1996 Huit-Zollars Correspondence 1000.026

# HUITT-ZOLIARS

H-Z Proj. No. 01-1022-04

TO: Town of Addison

Section 'A'

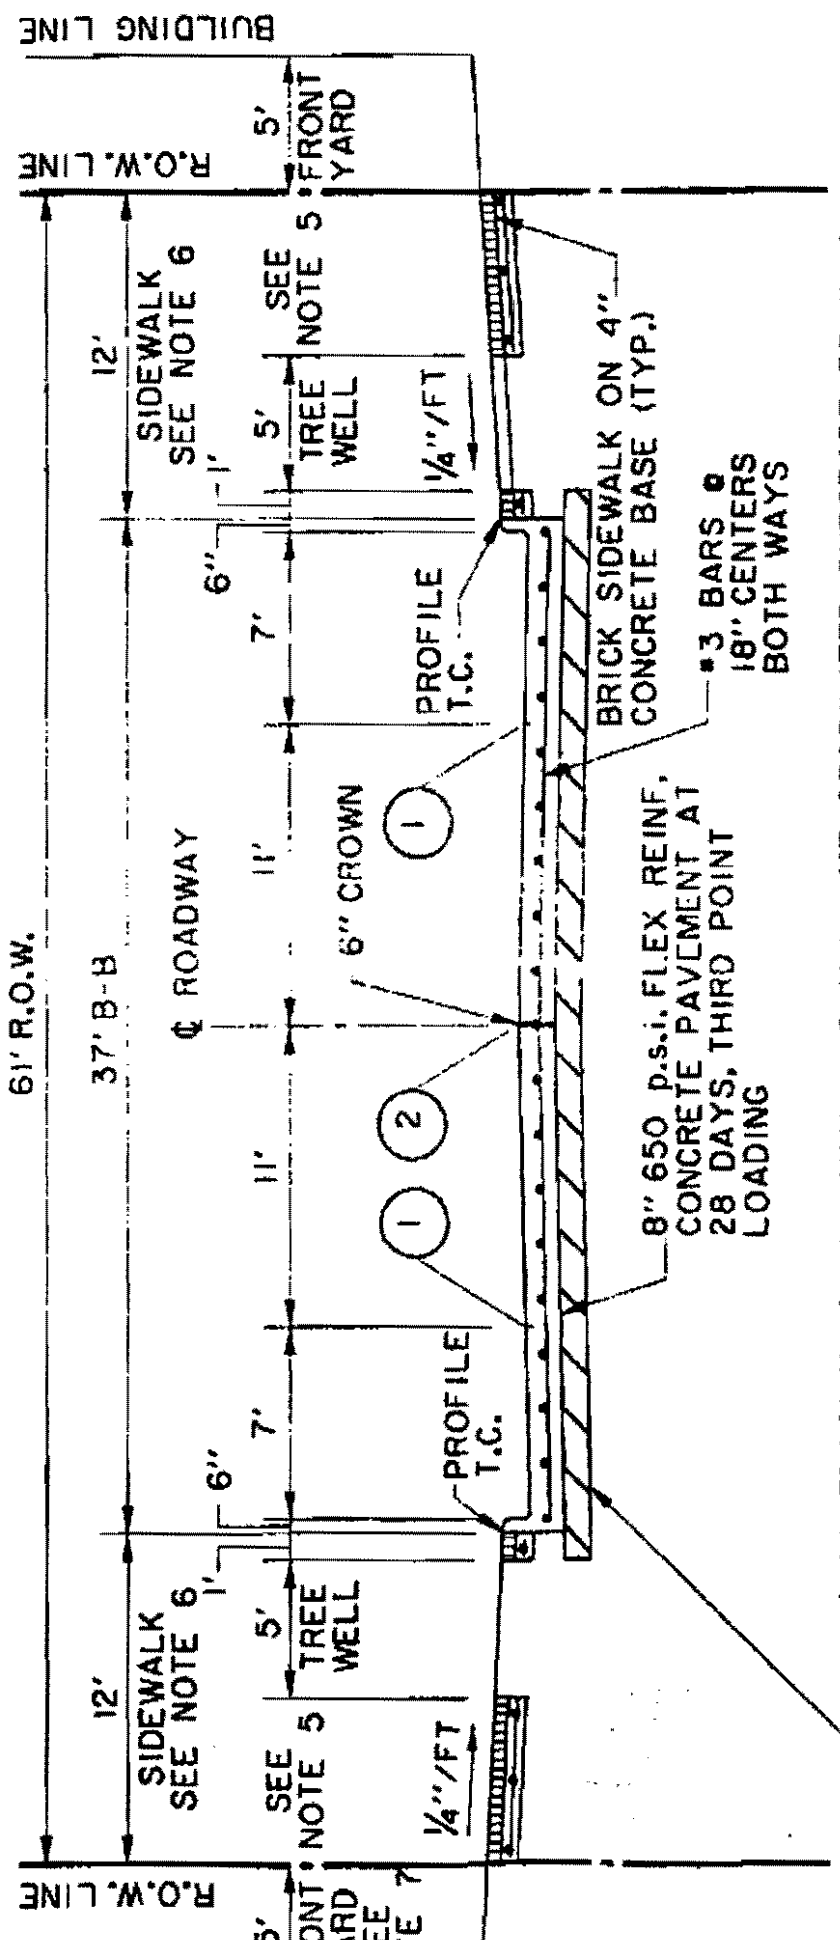
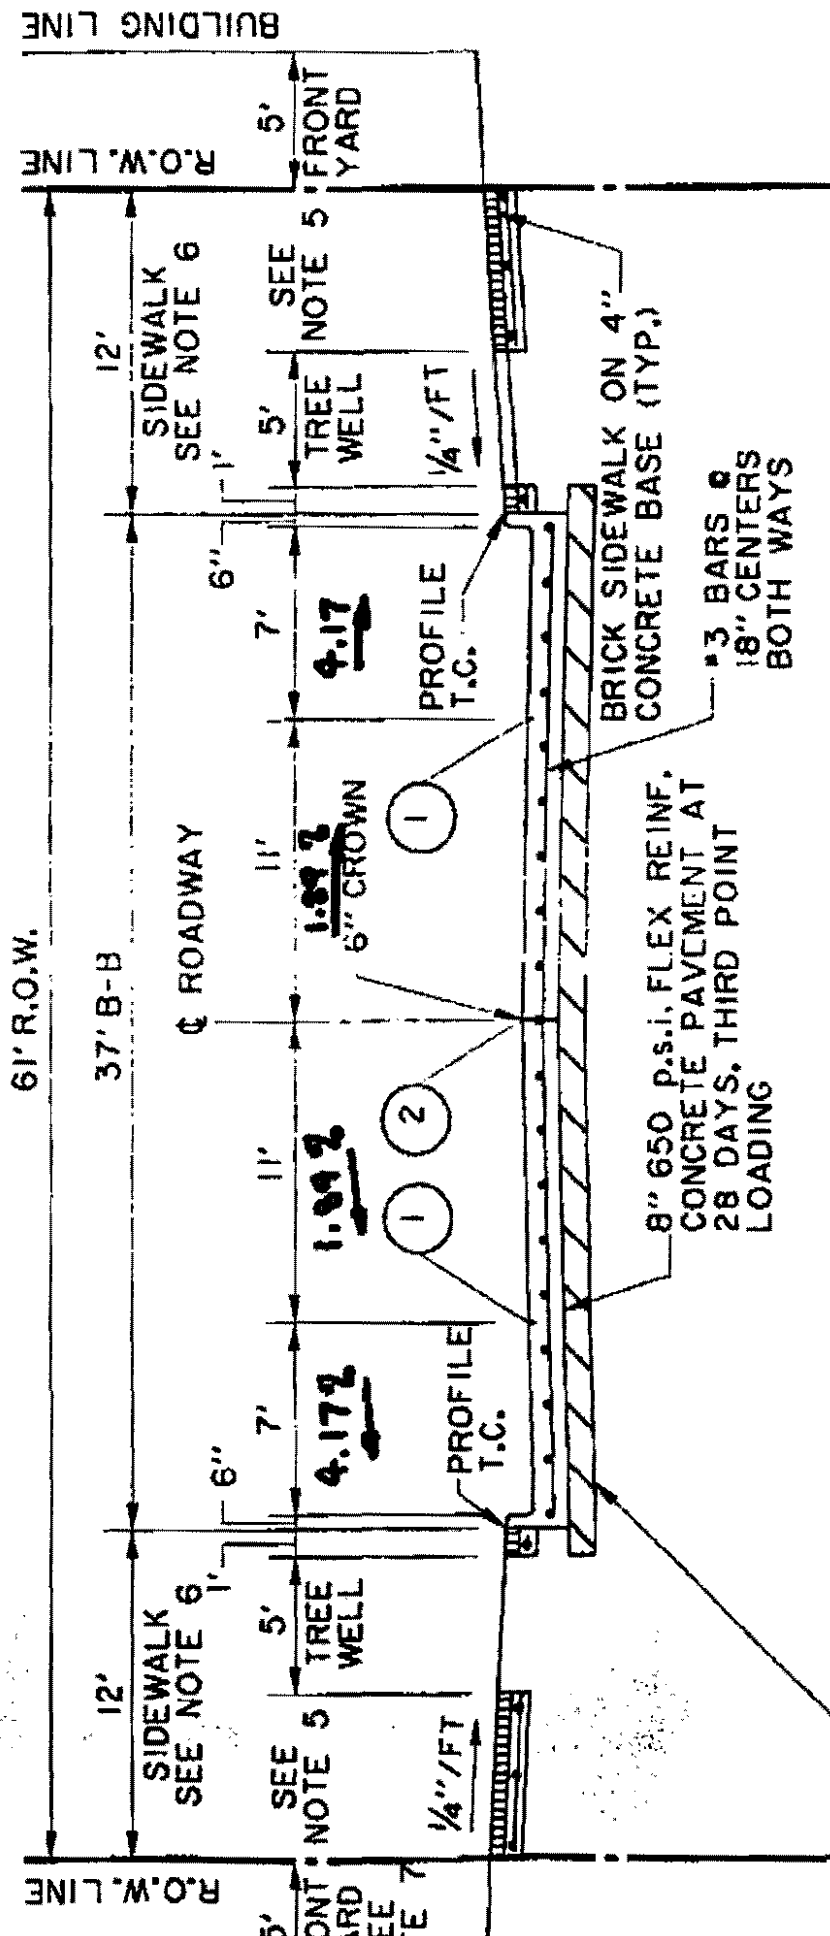
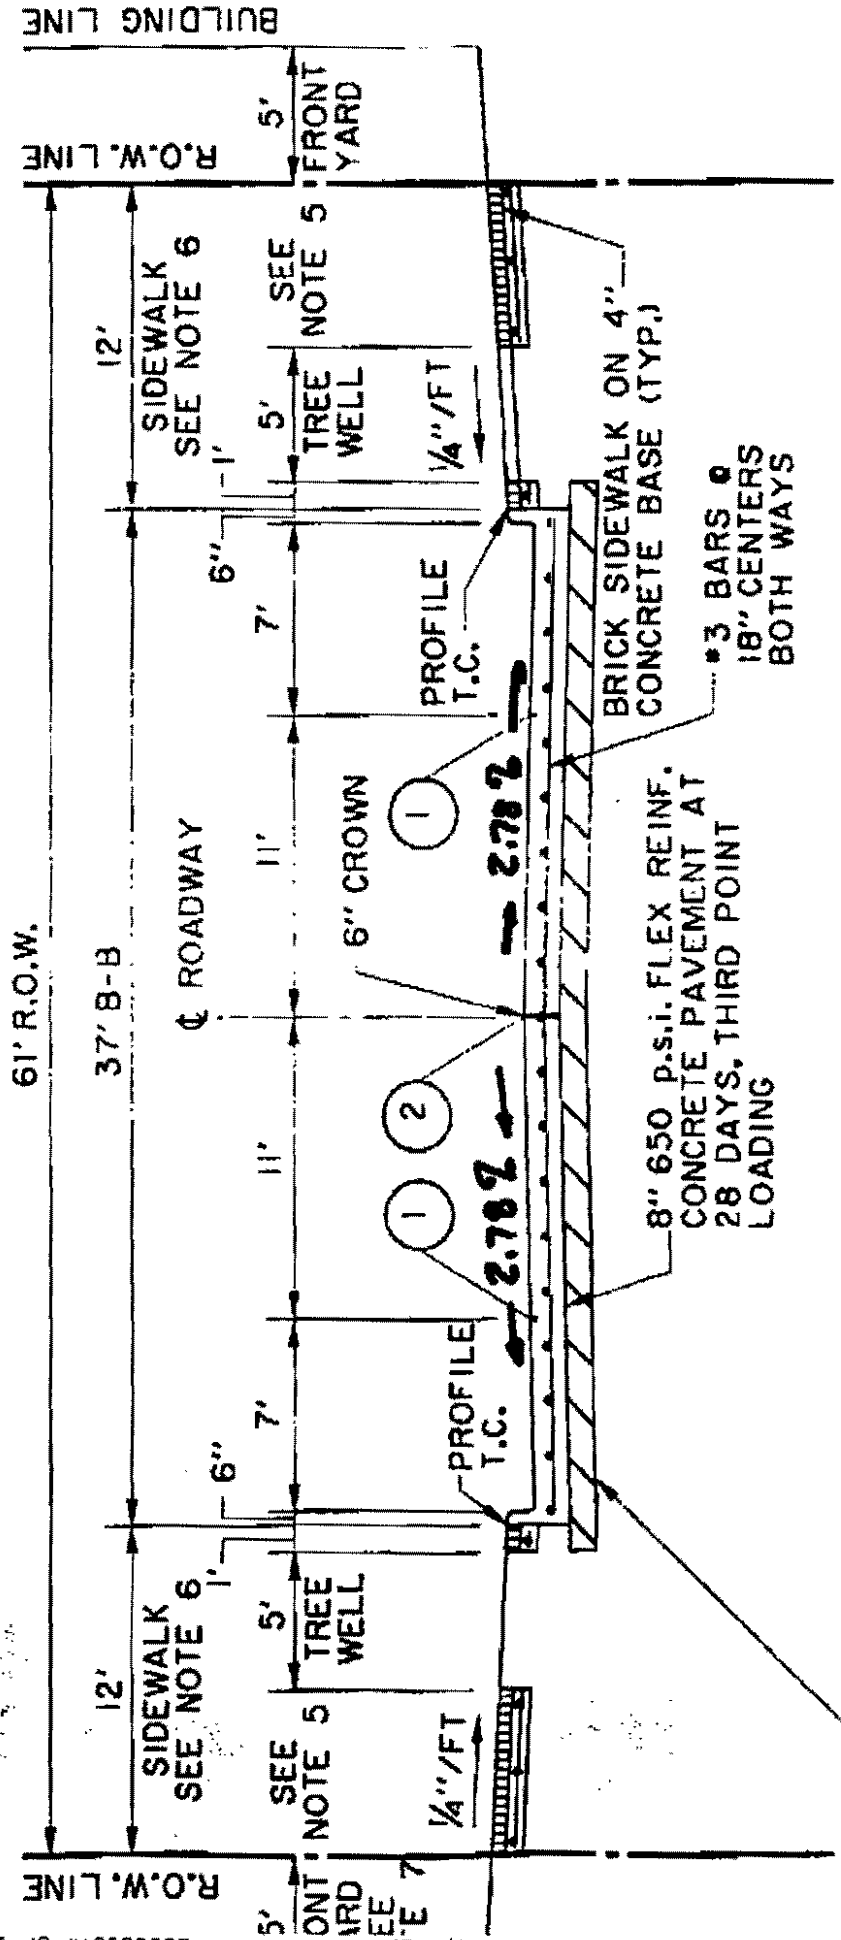
For the Residential Streets,  
McKamy & Morris, what type of typical  
section do you want: Normal Parabolic,  
Straight Crown, or Modified Straight  
Crown? look over the attached  
sections and give me a call. Thanks,
